ADDENDUM

PROJECT:	Grand Peaks Medical Clinic	ARCHITECT'S PROJECT NO:	1804
OWNER:	Grand Peaks Medical	ADDENDUM NUMBER:	1
BID DATE:	07.02.19	TIME:	2:00 p.m.
		ADDENDUM DATE:	06.21.2019

GRAND PEAKS MEDICAL CLINIC

3 ROOF DETAIL
 A4.3 1" = 1'-0"

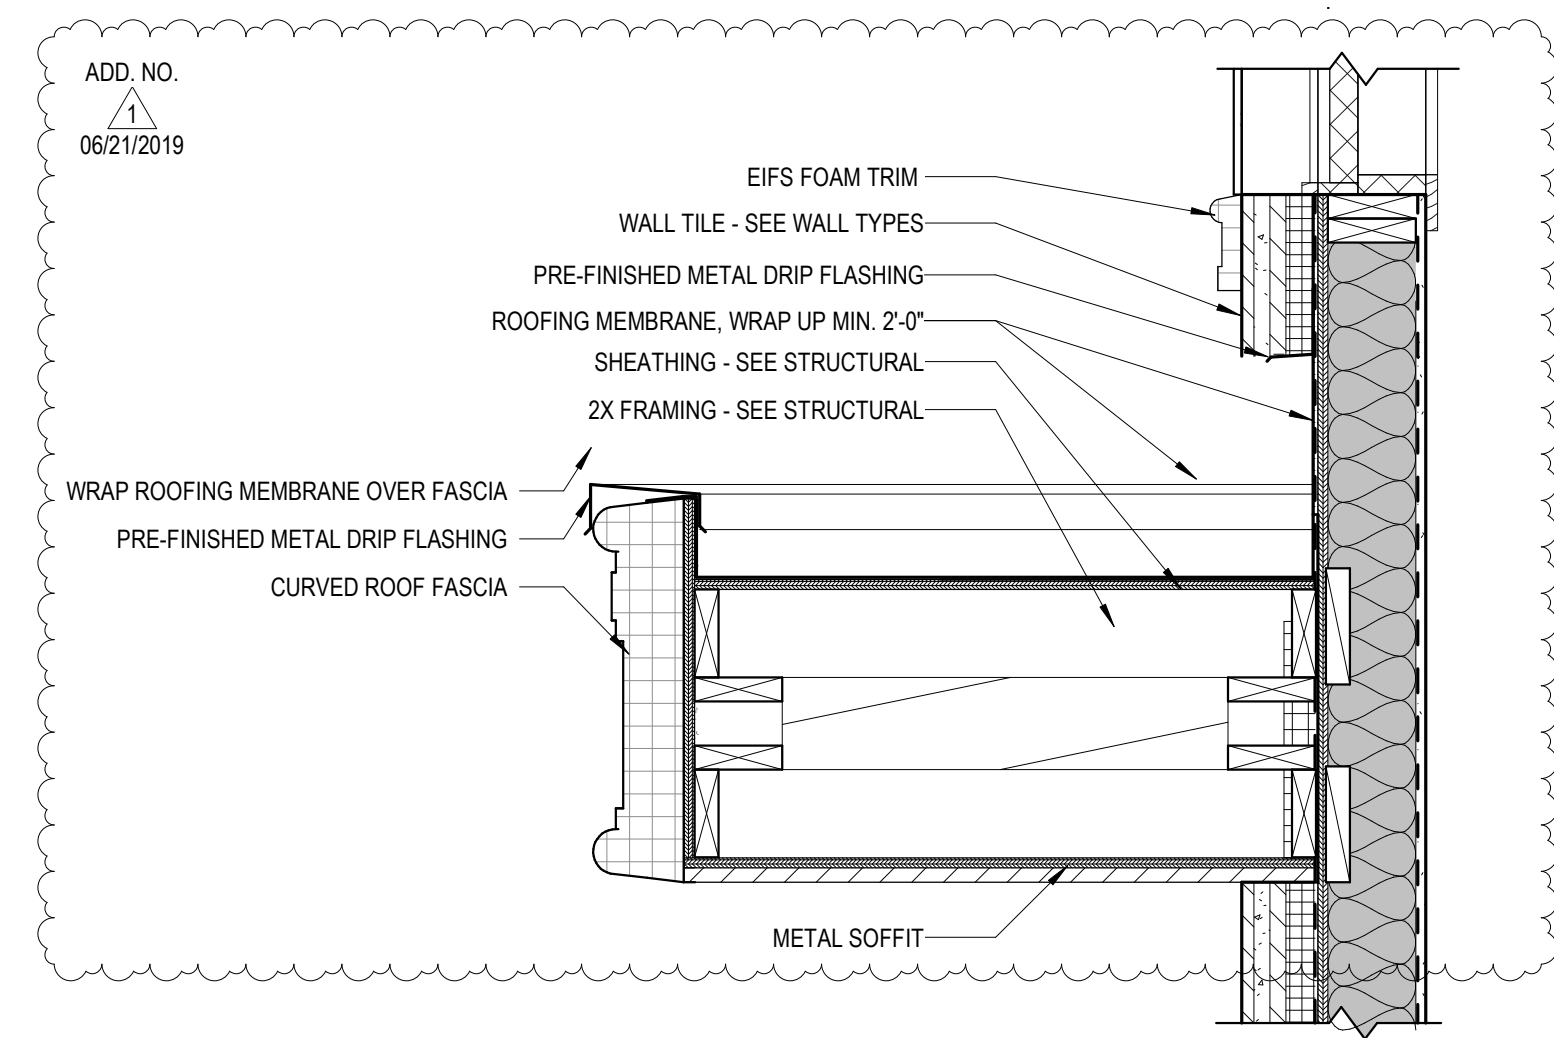
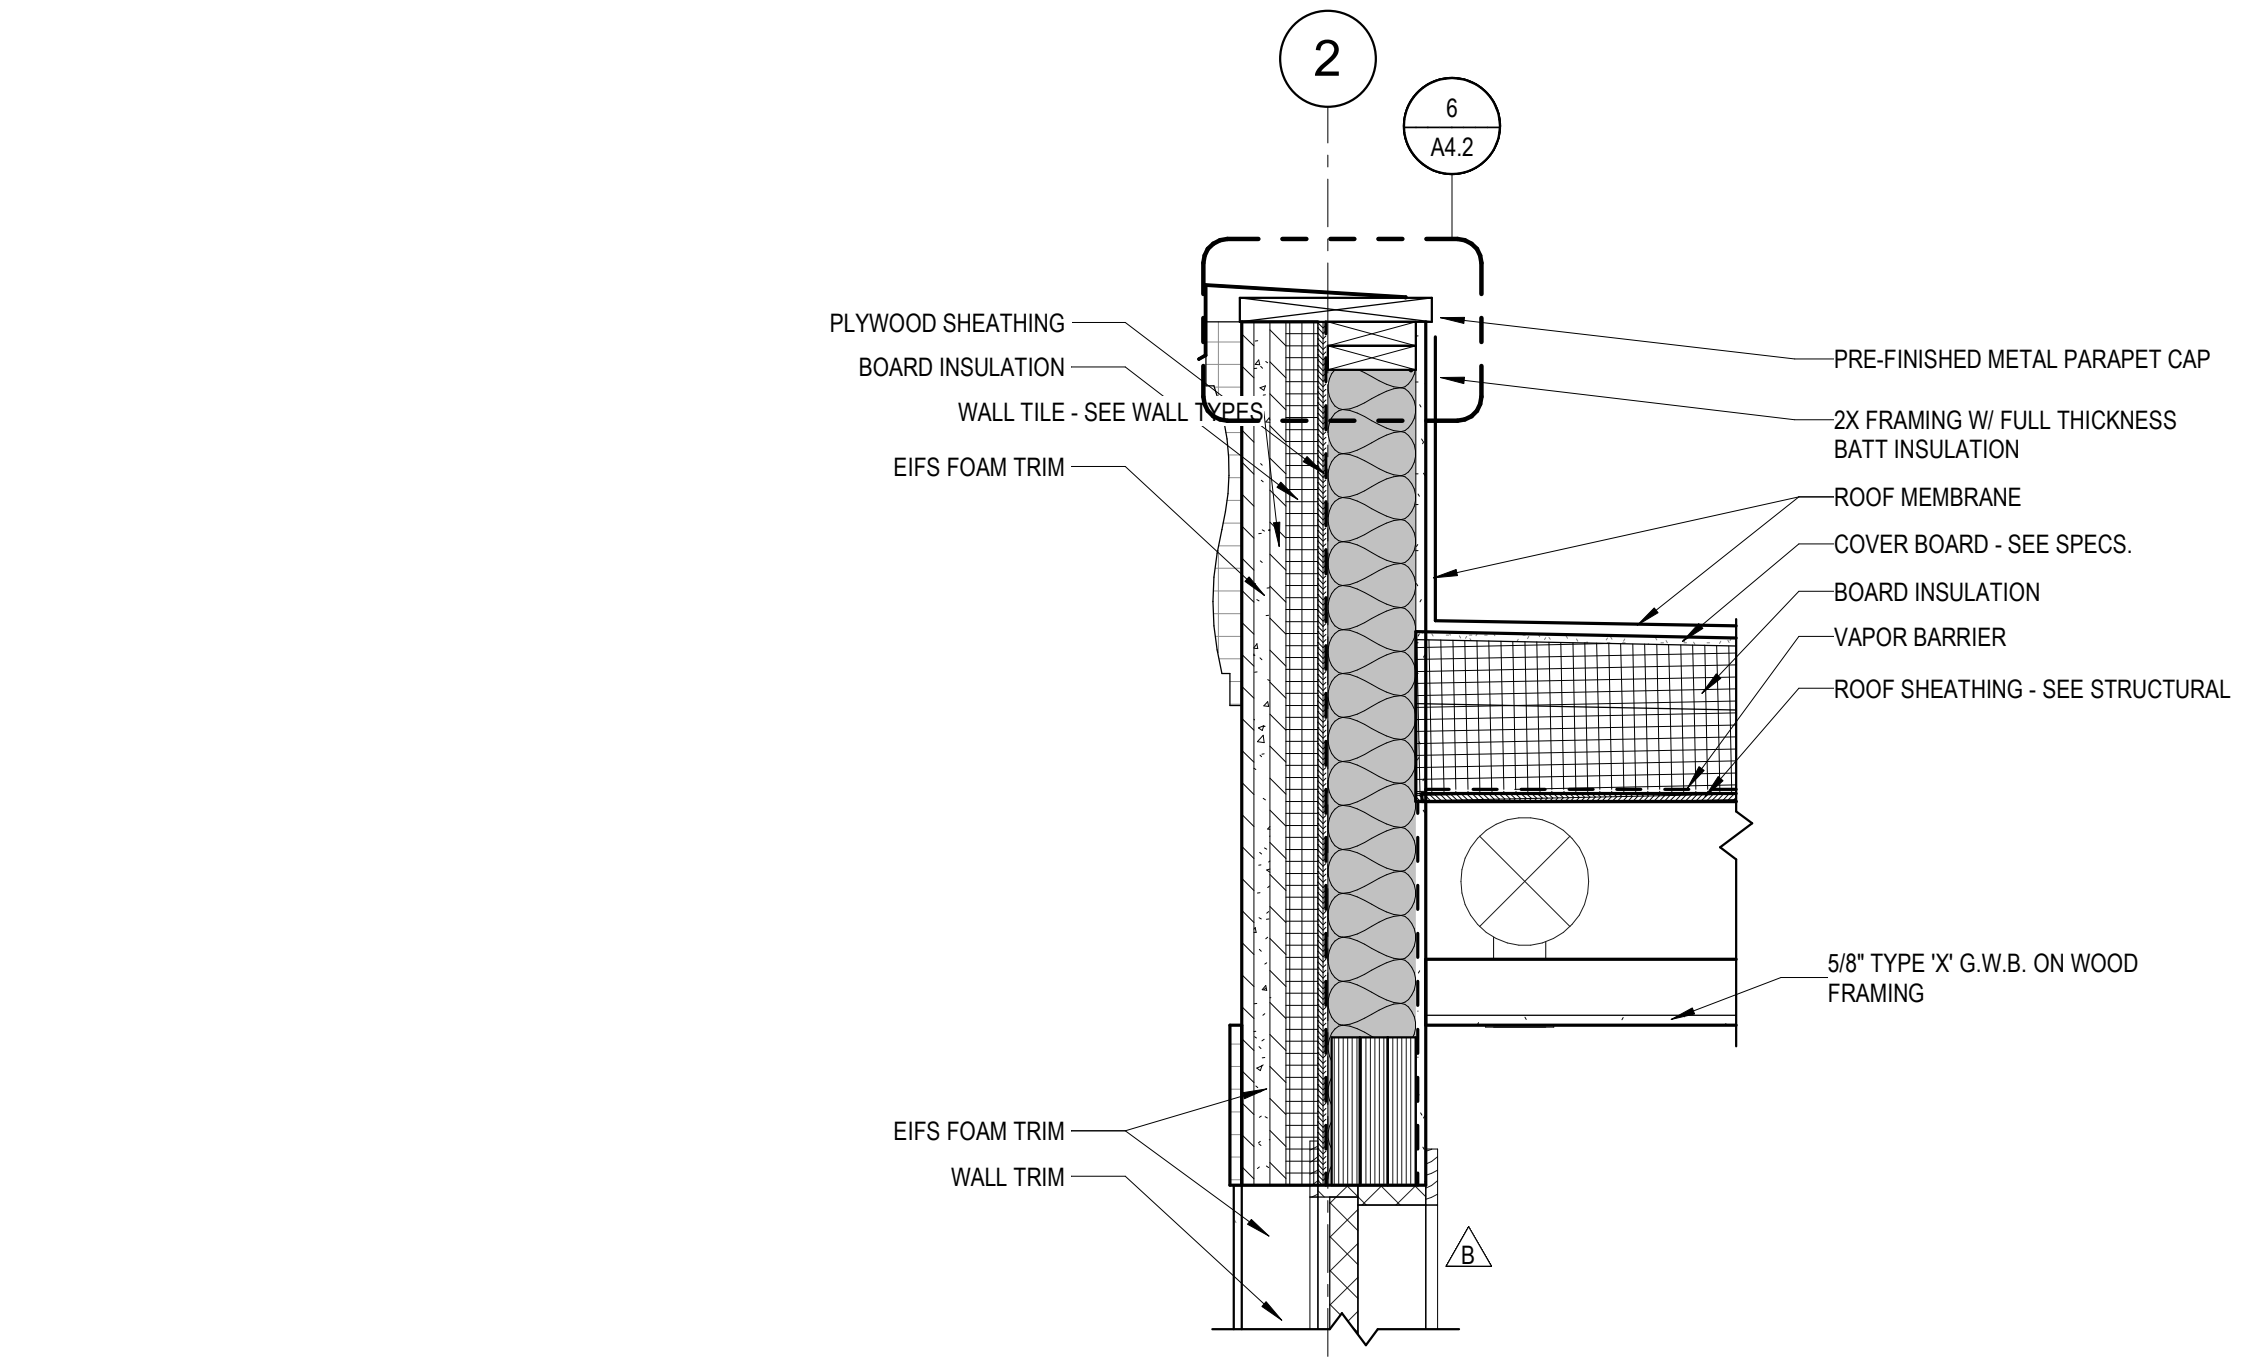
- 9. SHEET A4.3 – ROOF DETAILS
 - a. Revise detail 3/A4.3 – see attachment A4.3
- 10. SHEET A8.3 – INTERIOR ELEVATIONS
 - a. Revise 4/A8.3 MEETING CENTER 217– see attachment A8.3
